PLAN COMMISSION COMMUNITY DEVELOPMENT STAFF REPORT

MAECLIFF DRIVE – CANTERA POINT TOWNHOMES

August 21, 2025

VAR-2025-0012

SHEET 5 OF 18

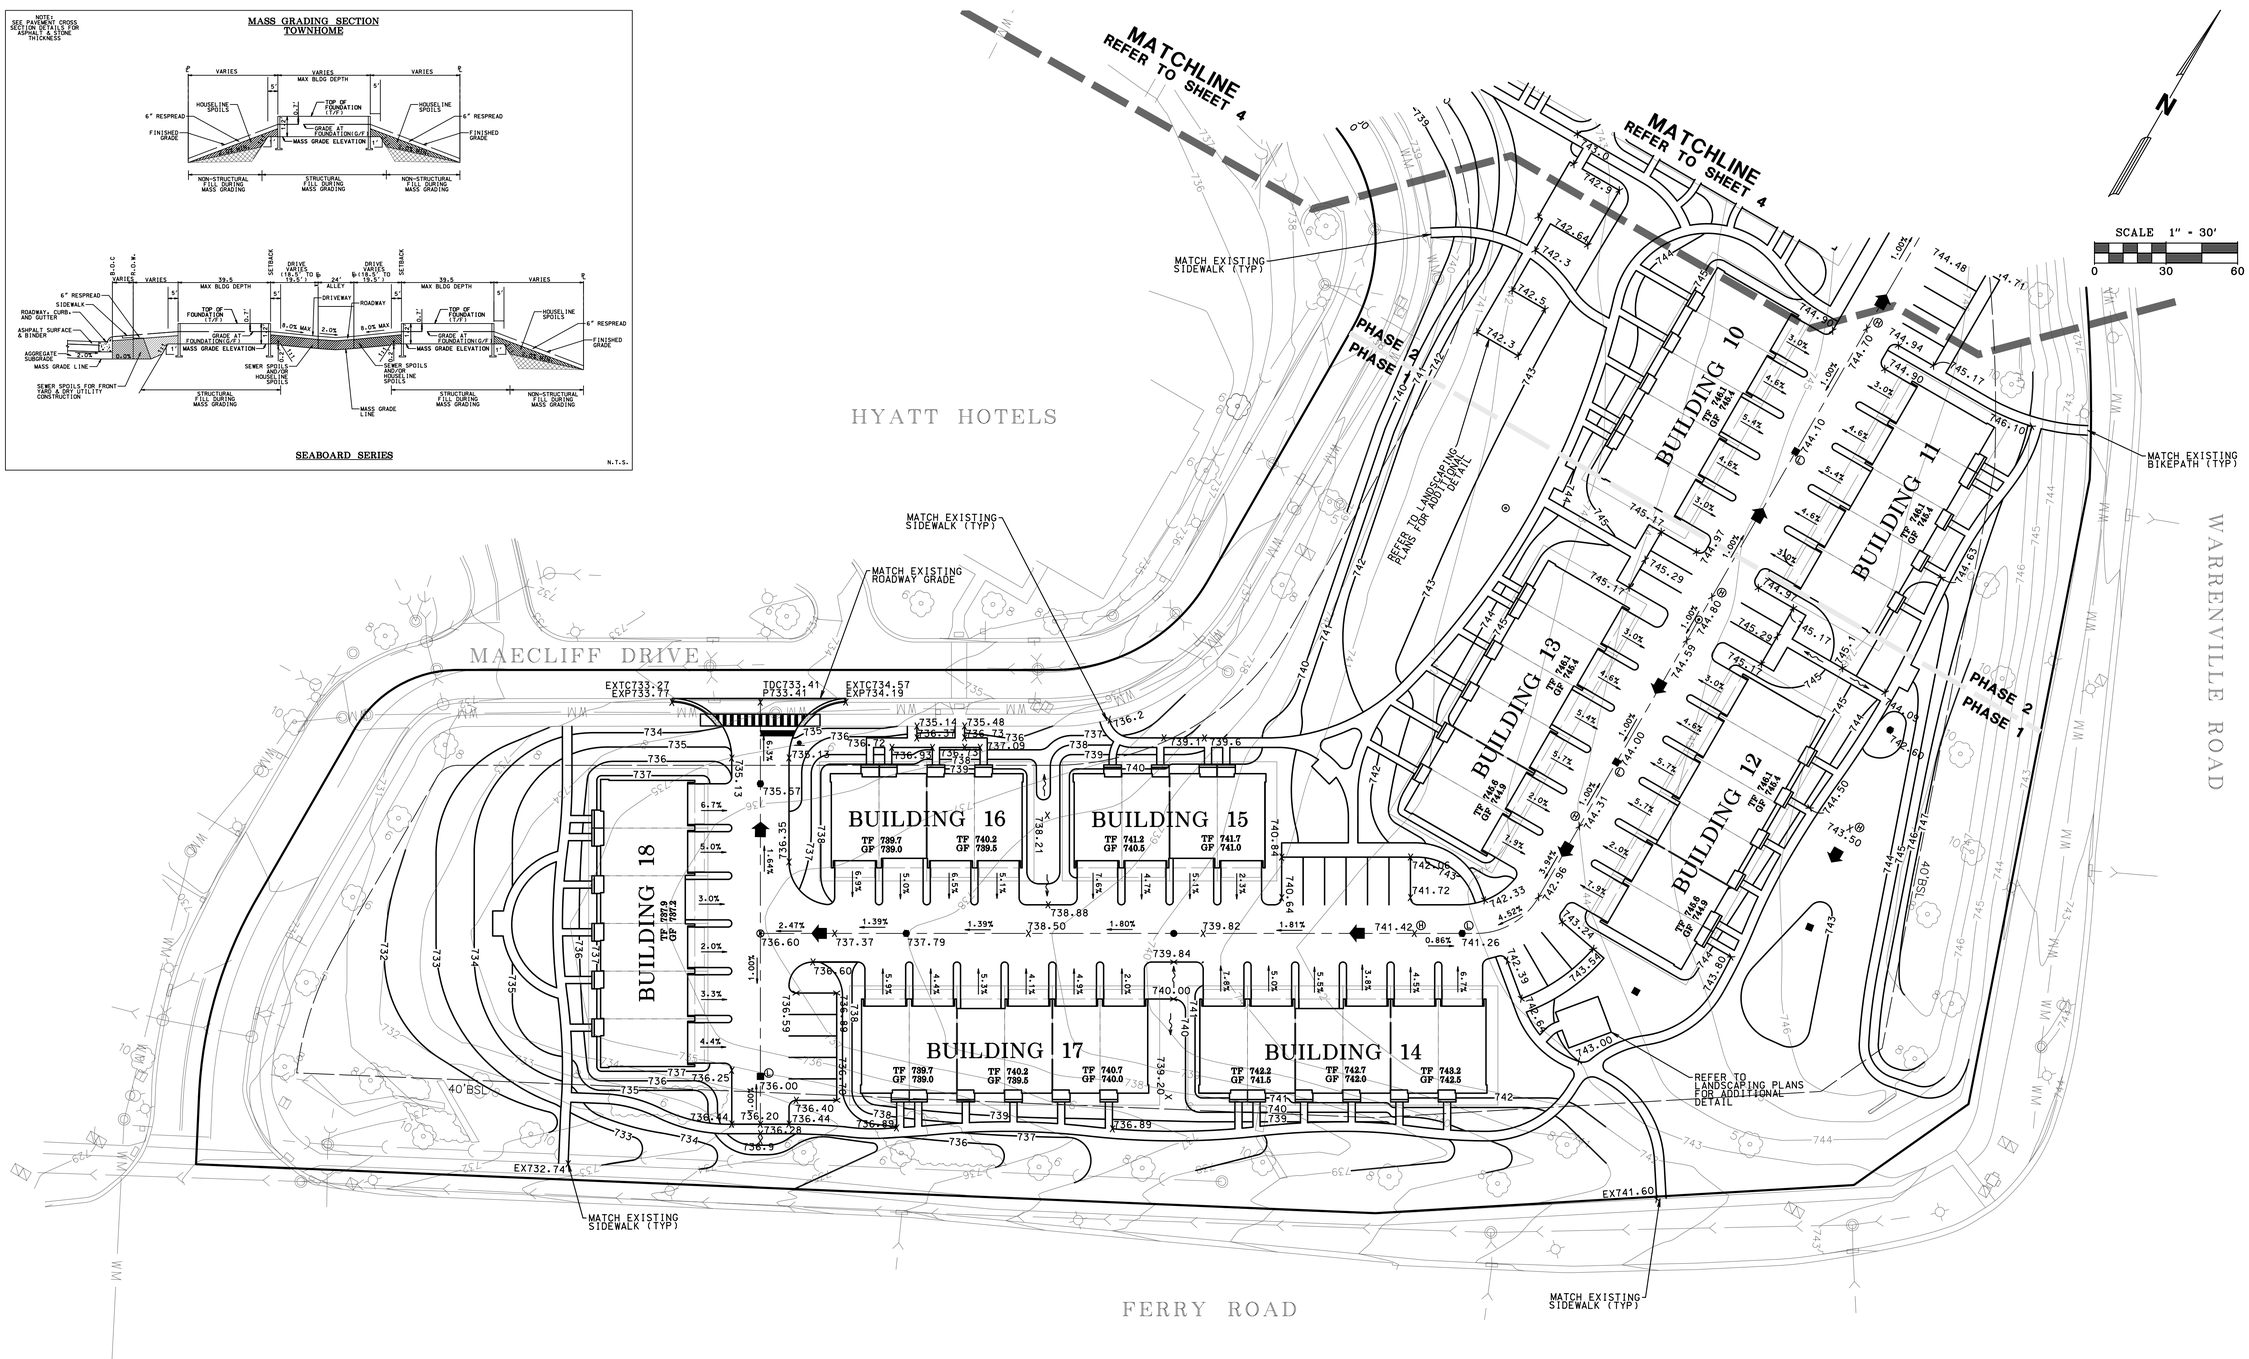
7. Grading Plan Sheet 4: Revise note # 5: "….slopes from the ~~right of way~~ **garage to common driveway (alley)** shall be…."
8. Grading Plan Sheet 5: Revise the Mass Grading Section Townhome to show the common driveway (alley) between drives to be 21 feet. Update the slopes for these drives on Sheets 4 and 5 to reflect this.

9. Grading Plan Sheets 4 and 5. Add spot grades at the point where the driveways meet the common drive (alley).
10. Note Detail Sheet 17: Make the Typical Common Driveway Cross Section and Typical Cross Section HMA Common Driveway to show 21' wide so that there are 20' of space between garage and common driveway (alley) edge.

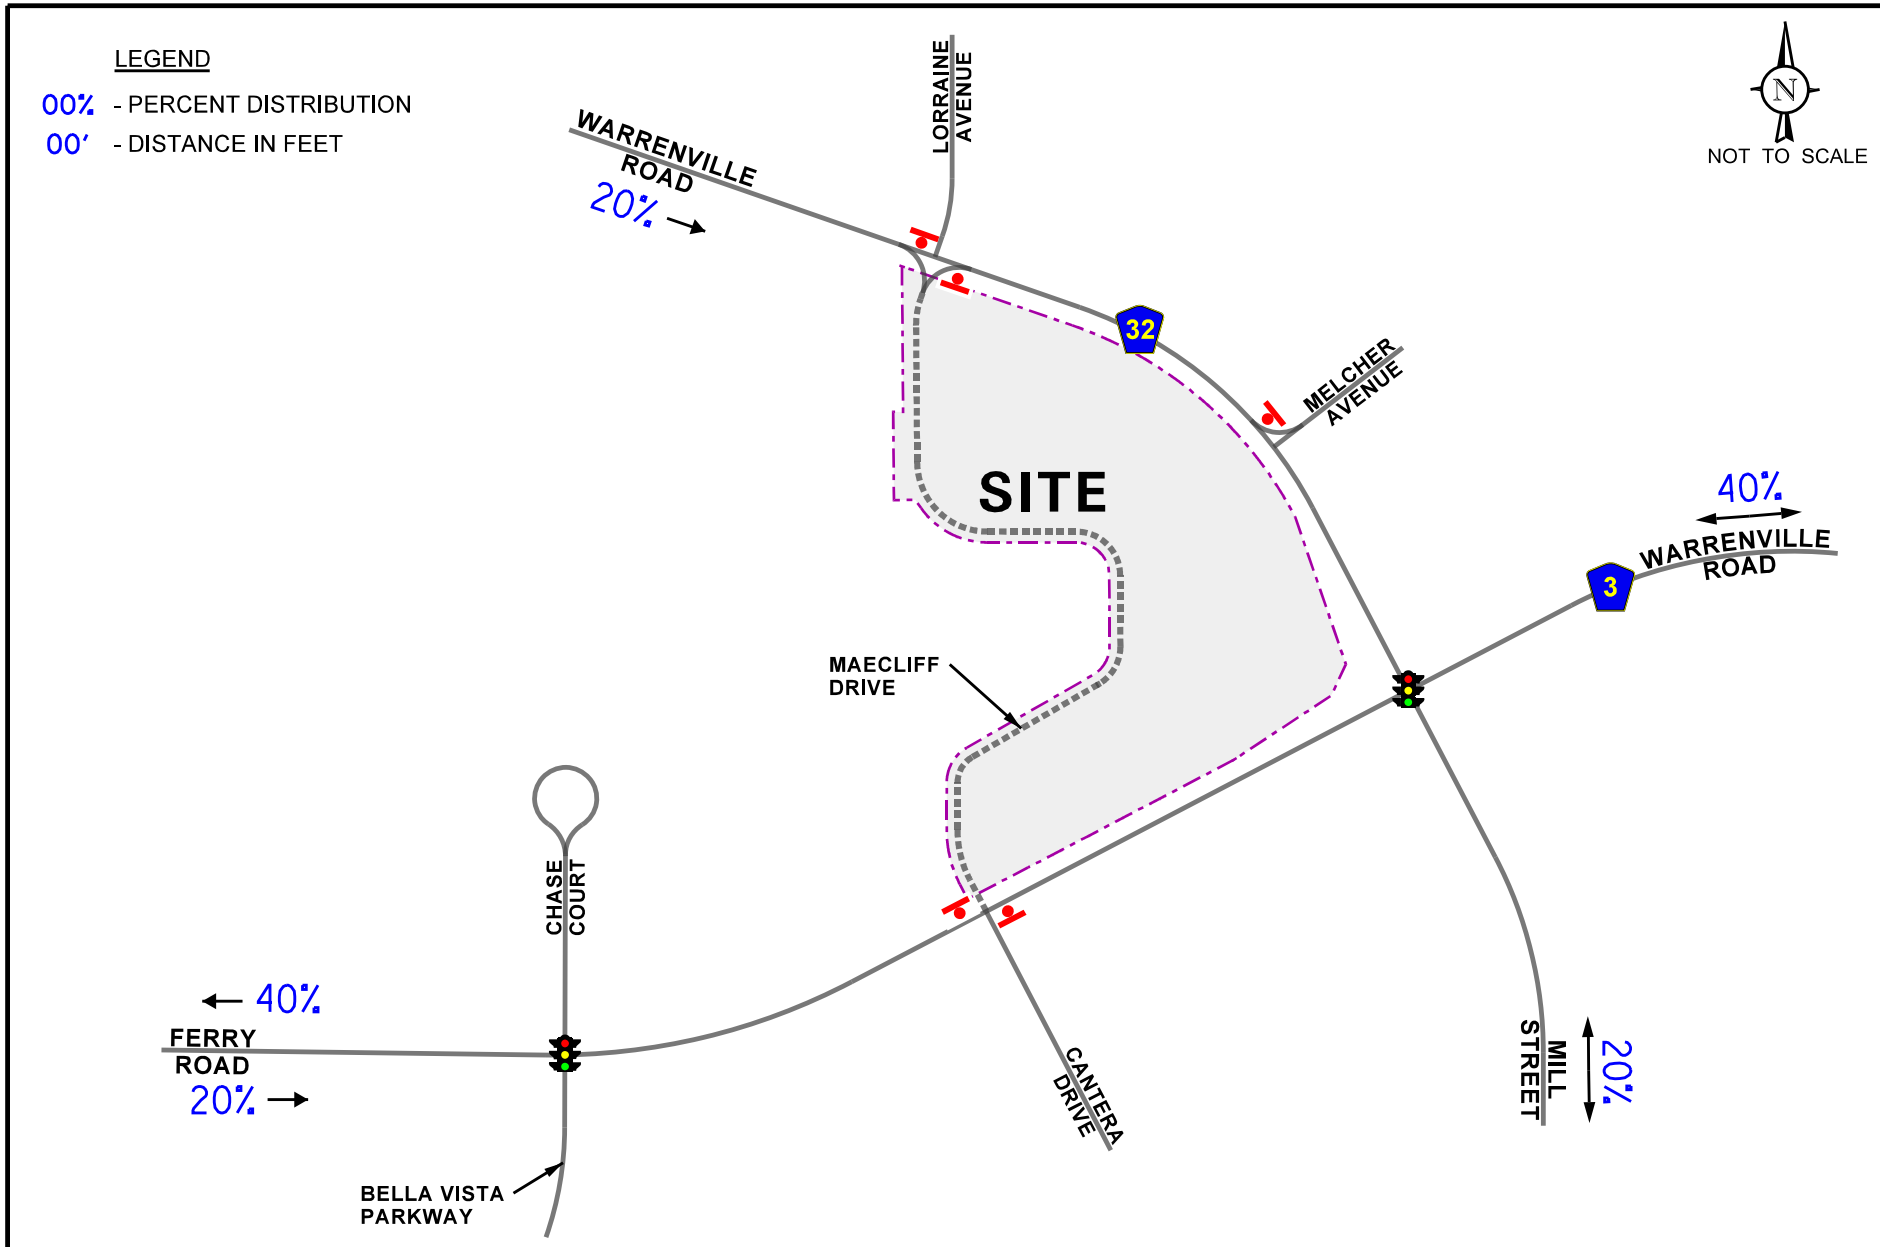
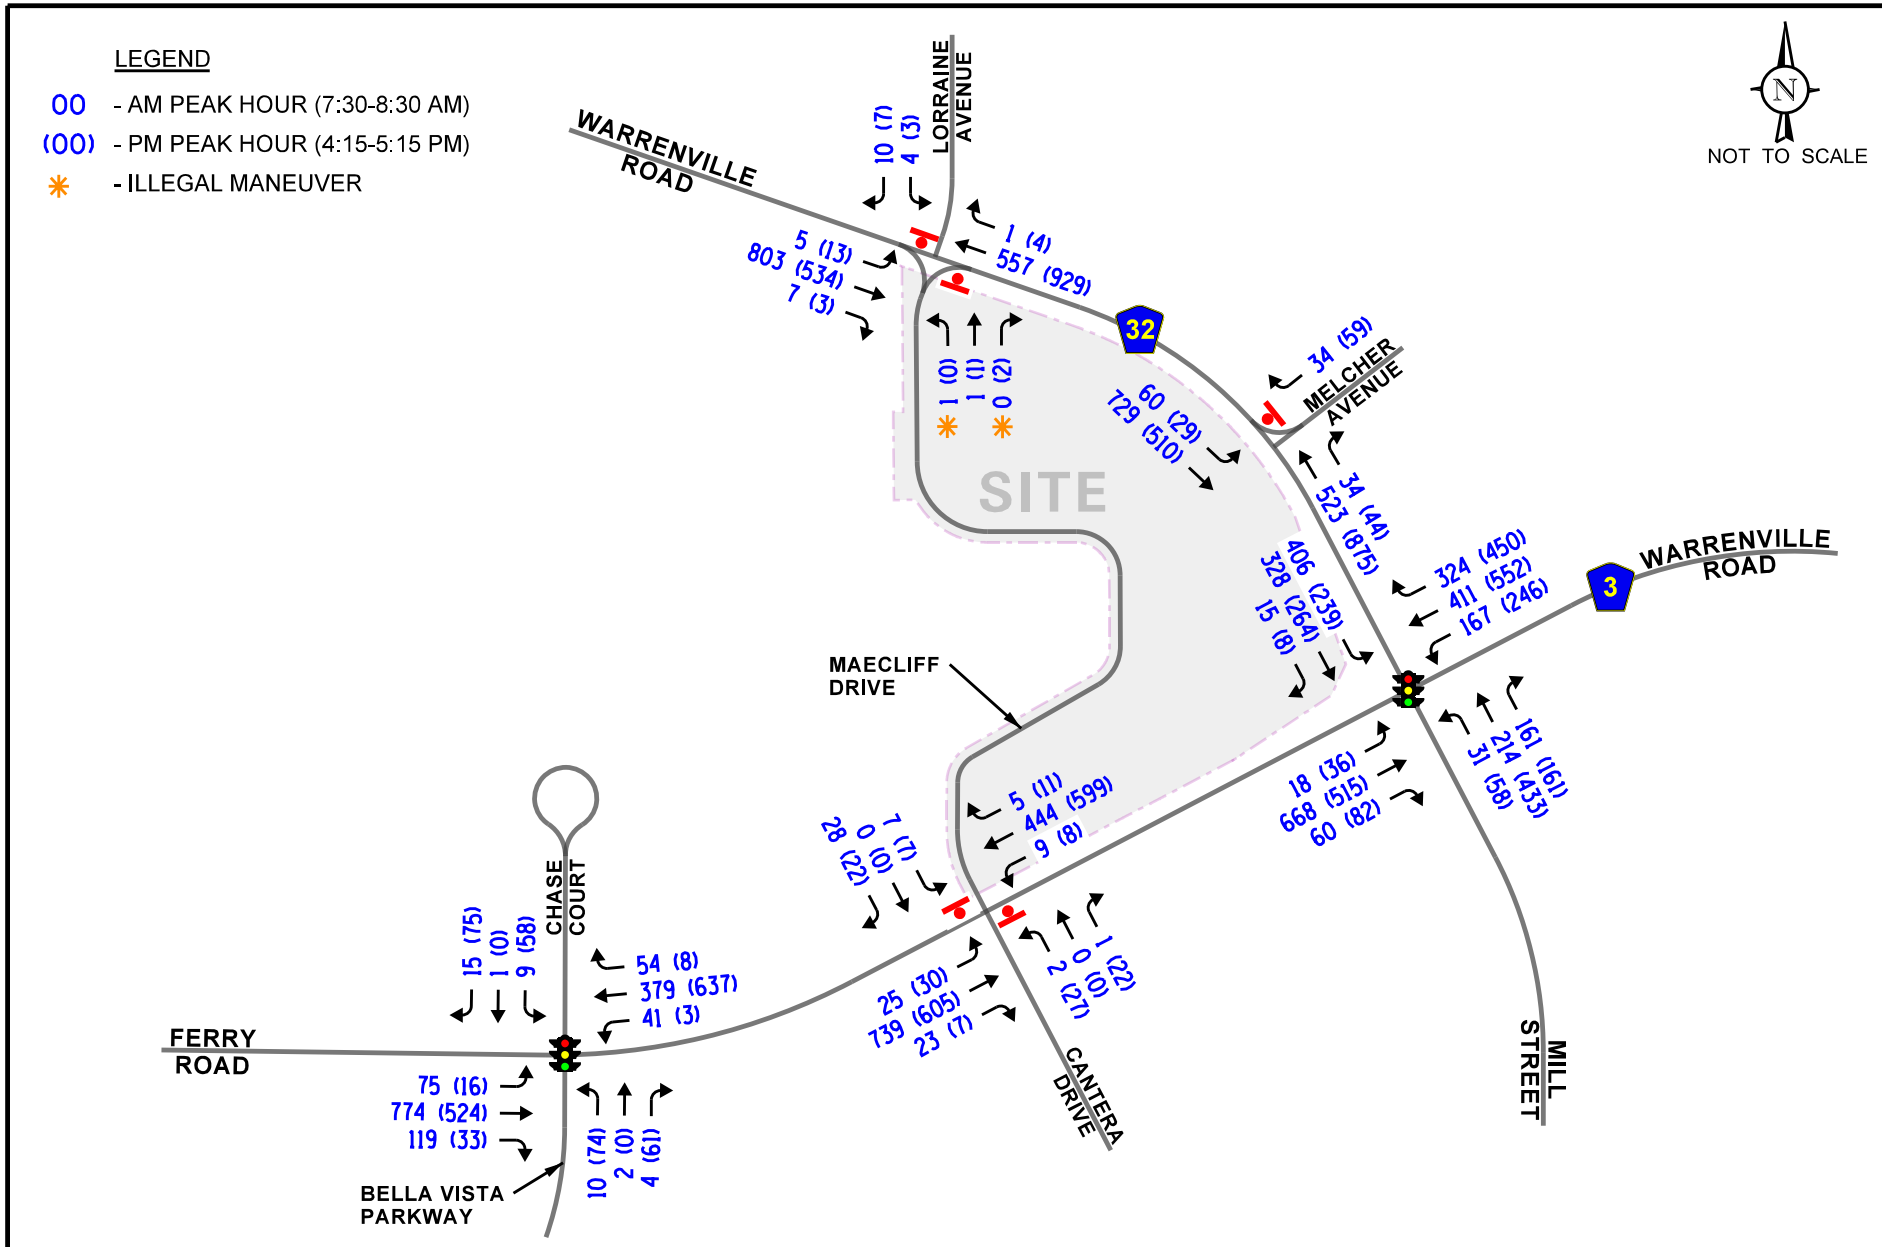
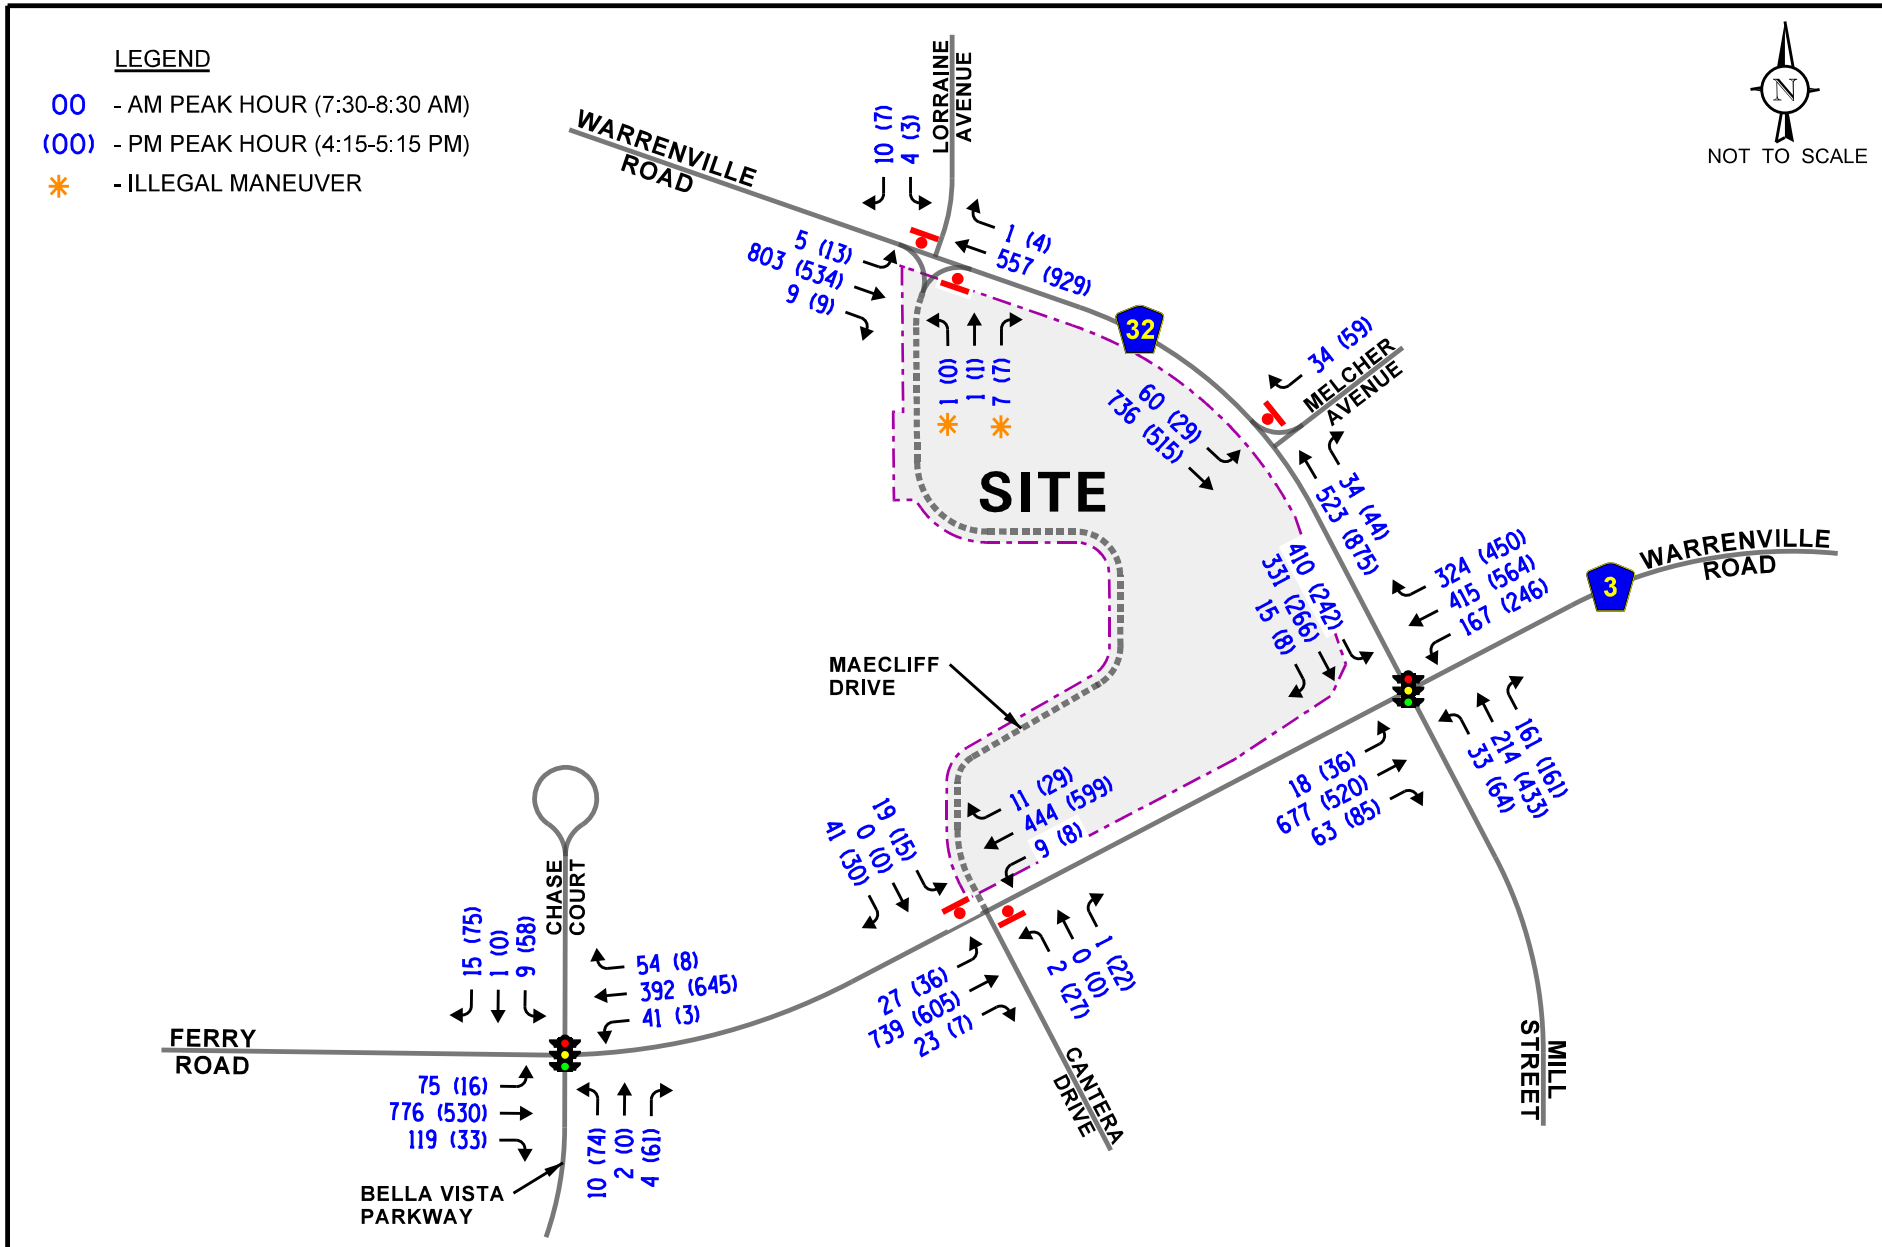
8. Update Figures 4, 7, and 8 to move the asterisk for the illegal maneuver to the through movement instead of the right turn movement from Maecliff Drive to Warrenville Road.
9. The traffic impact study (TIS) indicates the development would provide four access drives on the east side of Maecliff Drive; however, the site plan reflects three drives. Please update the TIS accordingly.
